Revised Environmental Assessment Addendum of Multiklient Invest Labrador Offshore Seismic Program, 2018–2023

**April 2019
LGL Report No. FA0106B-02**

INTRODUCTION

Figure 1. Marine shipping traffic density (routes per 23 km² grid cell) in 2016 in the MKI Project and Study Areas (depicted with small and large dashed lines, respectively).

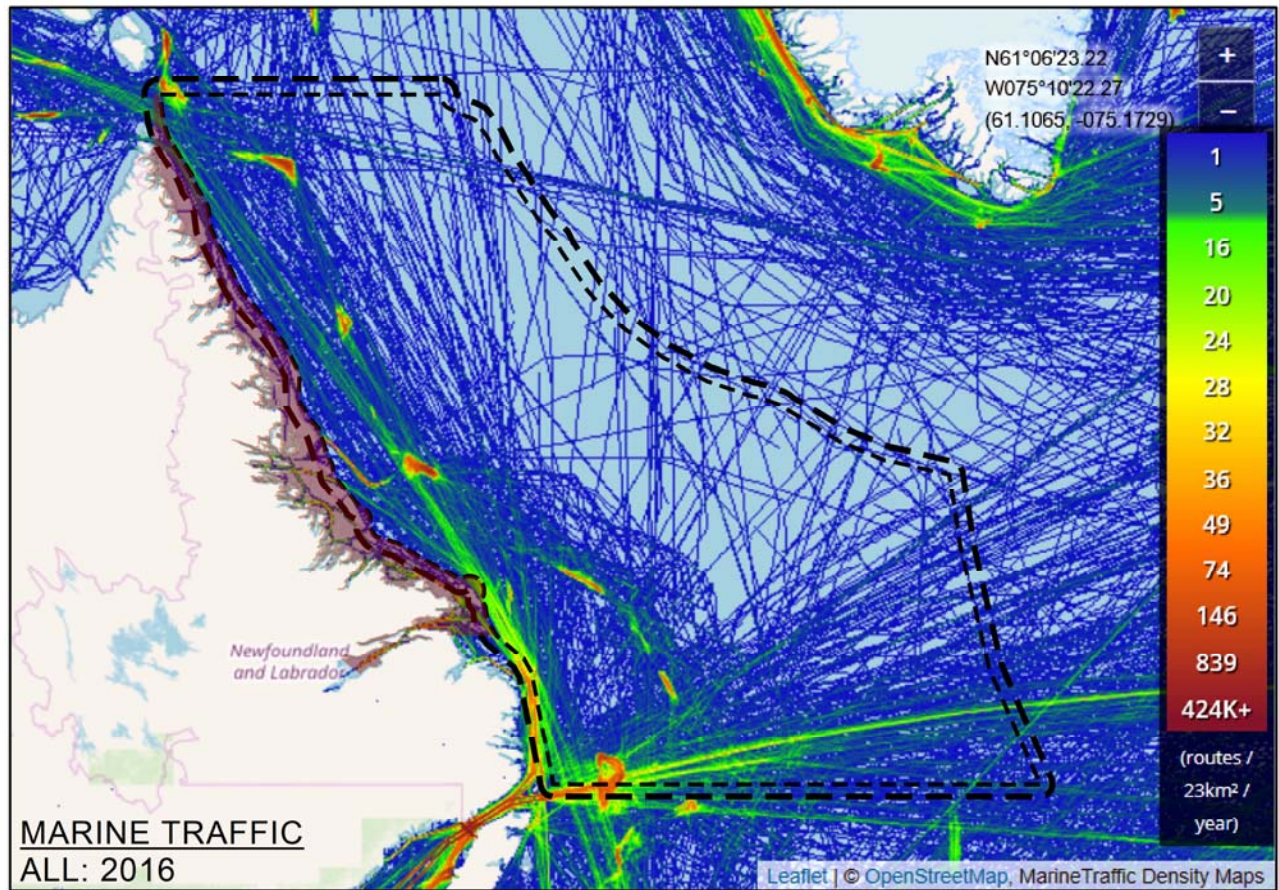
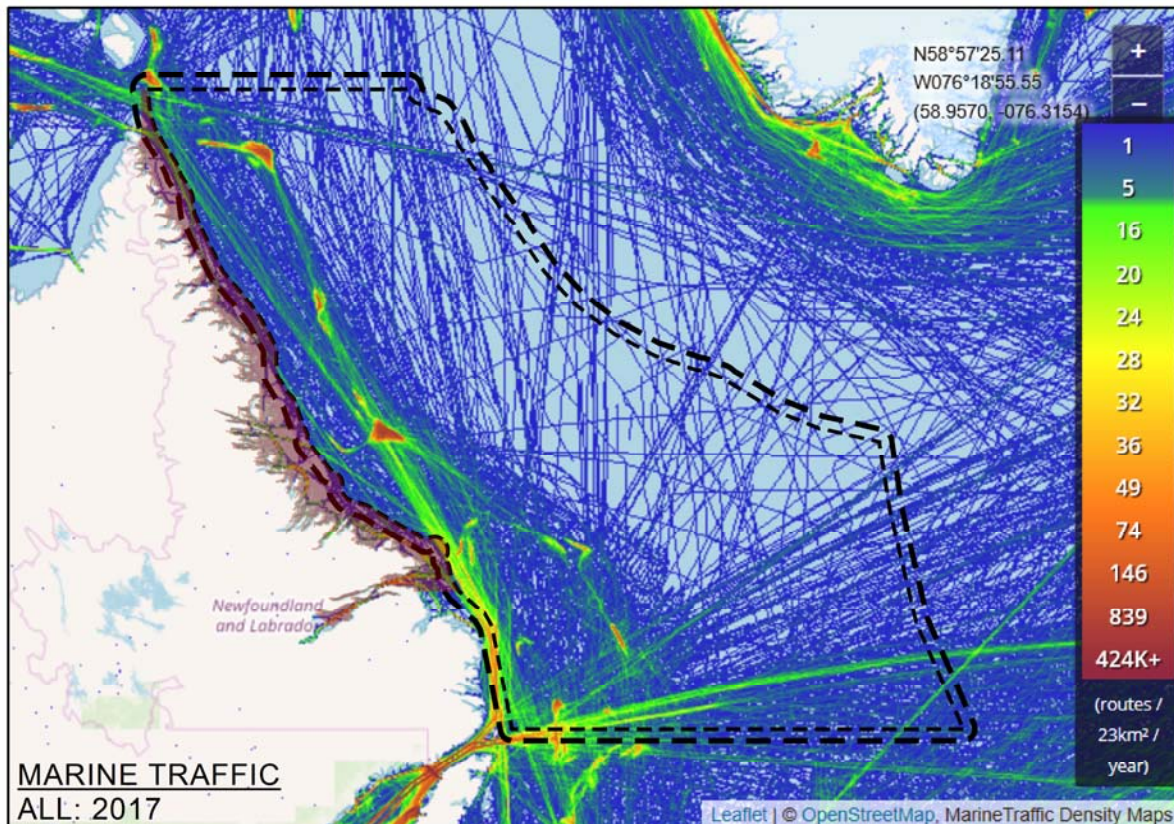
Follow-up Comment: On page 7, the proponent references an assessment of shipping traffic levels from the Labrador Shelf SEA. As this document was created in 2008 and is stated to cover only up to 10 years from its publication, it would be beneficial to reassess the impact of shipping traffic from more recent shipping data, especially if this project is expected to extend to 2023.

Response: Shipping activity in the Project Area occurs primarily during the ice-free months, typically June–November. Seasonal marine traffic consists of local transport and coastal ferries to/from Labrador ports, oil tanker and sea-lift cargo supply vessels servicing the eastern Canadian Arctic, bulk carrier transits to/from Voisey’s Bay, fishing vessels, ecotourism cruise ships, and seismic vessels. Year-round marine traffic through the Labrador Sea is mainly comprised of offshore commercial factory-freezer trawlers and freighters transiting between Greenland and eastern North American ports, and shipping of concentrated ore from mining operations in Voisey’s Bay (C-NLOPB 2008). Data obtained from Canadian Coast

Guard, Marine Traffic and Communication Services, identified 624 and 608 vessel trips through the Labrador SEA area in 2006 and 2007, respectively. Information from the Coast Guard was provided with caveats however, in that it only recorded activities of vessels of 500 gross tonnage or greater, and of these, it could not provide a complete listing of vessels that travelled non-stop through the Labrador SEA area (C-NLOPB 2008).

More accurate assessments of regional marine traffic has been facilitated by the ubiquitous use of AIS transponders by vessels and technological advances in data storage, processing capabilities and online commercial service providers over the past decade. Figures 1 and 2 show cumulative marine traffic density that transited through the Project Area for calendar years 2016 and 2017, respectively. Source data to generate maritime routes for all vessel traffic was obtained from marine AIS tracking information archived and processed by marinetraffic.com. Publicly available density maps are color-coded to indicate concentrated maritime activity/traffic routes. Online visualizations are dynamic and based on unique vessel transits through a variable grid-cell size based on chosen zoom-level of a worldwide interactive map. Figures 1 and 2 are presented with similar scale for ease of comparison; vessel routes ranging from 1 to >800 per 23 km² grid-cell. Figure outputs were centered on the Labrador Sea, georeferenced (ArcGIS), and 'The Zone' and Project and Study Area boundaries were overlain to provide spatial context relative to the MKI Labrador offshore seismic program.

Within the MKI Labrador offshore Project Area, marine traffic density is concentrated in the southwestern corner at the confluence of marine routes between the Strait of Belle Isle and the eastern coastline of the Great Northern Peninsula of Newfoundland. Localized concentrations (orange/red clusters; >40 vessel routes per 23 km² grid-cell) adhere strongly to commercial catch (0.1x0.1 decimal degree) grid data for both 2016 and 2017. Specifically, northern shrimp catch effort at depths between 200 and 500 m in the northern half (*i.e.*, NAFO divisions 2H, 2G, 2G/0B) and southwest corner (2J) of the Project Area; Greenland halibut fishery along the Labrador Shelf (2J); and snow crab fishery locations at the southwestern extent of the Project Area (2J). Overall, shipping traffic levels through the Project Area are considered low, particularly in areas distant from coastal shipping routes. Shipping data from 2016 and 2017 confirm the conclusions made in the Labrador SEA (C-NLOPB 2008). Behavioural responses to periodic ship transits by marine mammals are expected to be short-term and localized. MKI (as well as other seismic operators) take steps to avoid close approach to other vessels. As such, while some animals may receive sound from a seismic program(s) and other vessels offshore Labrador, the current prediction is that no significant residual cumulative effects will result from exposure to underwater sound.
